Plan of Shafting

Messrs. P. Smit Jrs

S/s no. 375

"Camaplein"  
Rot. 16019

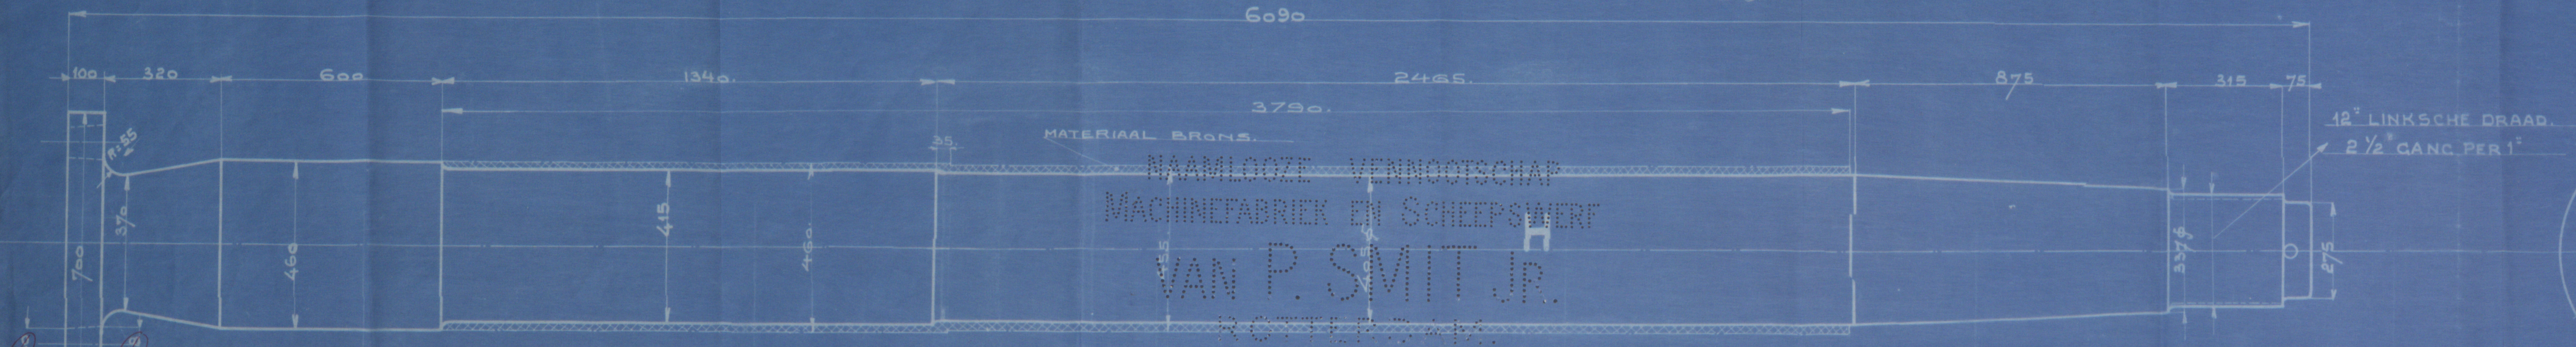
*Diameter of coupling bolts at the joining faces to be not less than 86 mm.*
